# matching nrf24 to 100ohms balanced

I want to use the nrf24l01+ with the se2436 amplifier, but the input of the amplifier requires an input of 100ohms balanced, while the nrf24 has a balanced output of  $15\text{ohm} + j88\text{ohm}$  according to the datasheet.

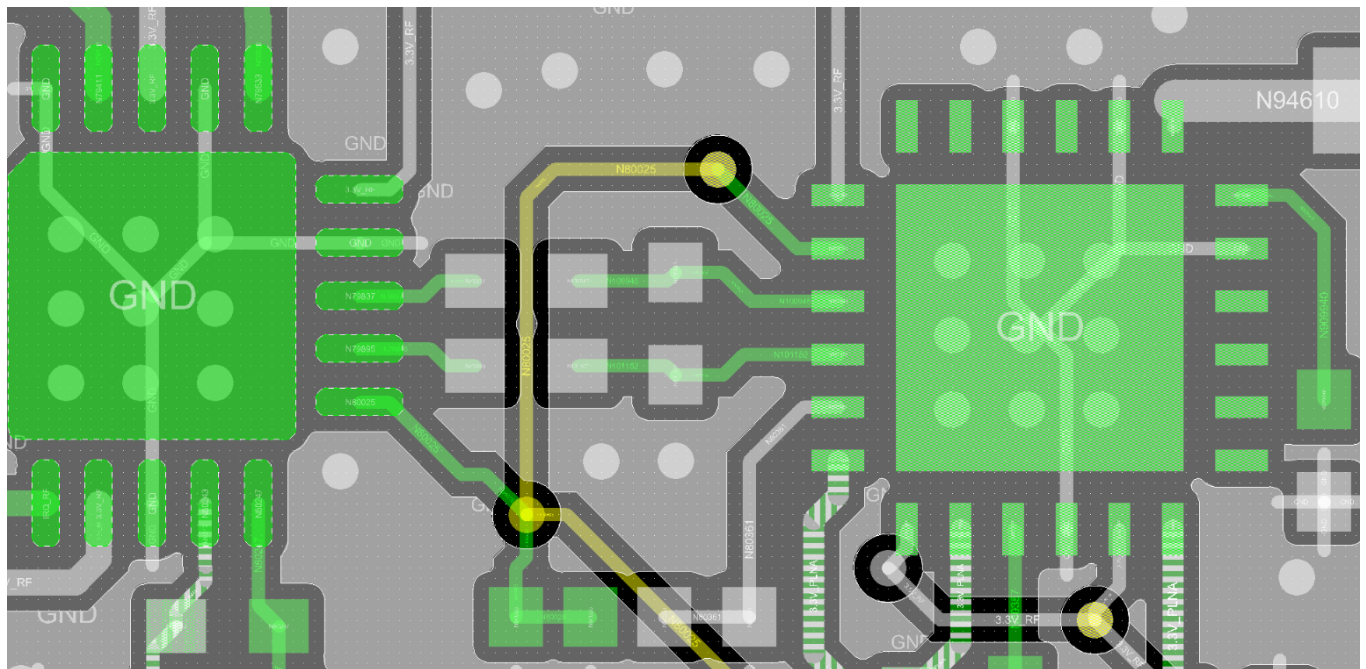
Close, but not quite right. The component values would be half you show for the topology you have chosen.

Also, since you are within an octave or so of SRF for these components the actual value will be a little less. I normally use the MuRata Chip S-Parameter & Impedance Library app to look up real impedance values. Though most respectable chip manufacturers also publish their real component data.

So that being said, the real series inductance should be about  $7.5\text{nH}/2$  or the most available standard size will be  $3.9\text{nH}$ . You are generally better off buying components that comply with the standard number scheme then trying to buy something that is the precise mH.

Then the best approach for the cap is a  $1.5\text{pF}$  straight between the two legs. Just skip ground. The way you have it the effective impedance is twice what you thought it was.

The stripline doesn't have to be a diff pair. Just treat it as two  $50\text{ohm}$  lines that are coplanar with ground. and stick them next to each other close enough that you still have room to place the series components.

You are going to need to keep this match really close to the nRF for it to be correct. You should be using 0402 or 0201 parts.

Yes that is the correct way to power it. You run VDD\_PA to VB. Remember to hook up the logic solution from nRF to SE2436. You should make sure the SDK for the nRF24 supports PA/LNA control. This is the best way to drive an external amp as there isn't a lot of good feedback with the RF events to do it on your own. I only code for nRF52 so I can't advise on the software link between softdevice and the hardware for nRF24. Otherwise you can use VDD\_PA to drive the SE24 but the downside is it will be in an lna on state all the time whenever the pa isn't on. Not the best thing for low power consumption.
